January 6, 2012

In Reply Refer To: HSST/B-227

Name of system:	High Tension 3-cable median and roadside barriers
Type of system:	Generic cable barrier system
Test Level:	NCHRP Report 350 Test Level 3
Testing conducted by:	Texas Transportation Institute
Task Force 13 Designator:	SGM01b
Date of request:	December 23, 2010
Date initially acknowledged:	January 7, 2011
Date of completed package:	January 7, 2011

Figure 5.15. Summary of results for NCHRP Report 350 test 3-11 on the low-tension wire rope barrier system.

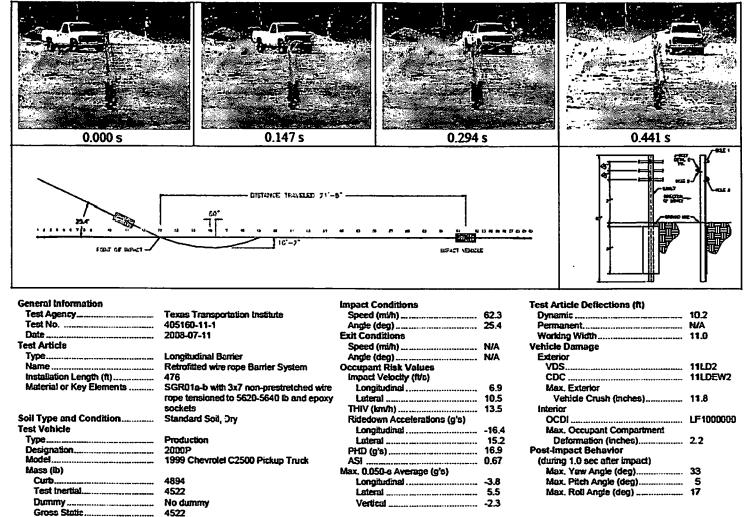
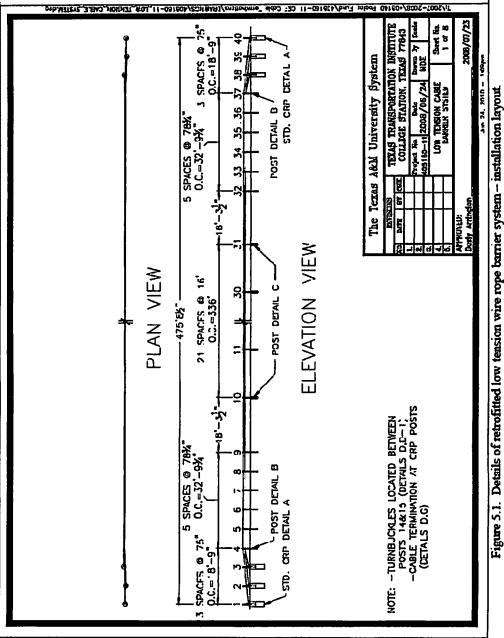
Enclosed for reference is the test data summary sheet showing the crash test and results which were in reasonably close conformity with NCHRP Report 350. The vehicle remained upright and deflected the barrier 10.2 feet. A working width of 11 feet should be used for design purposes.
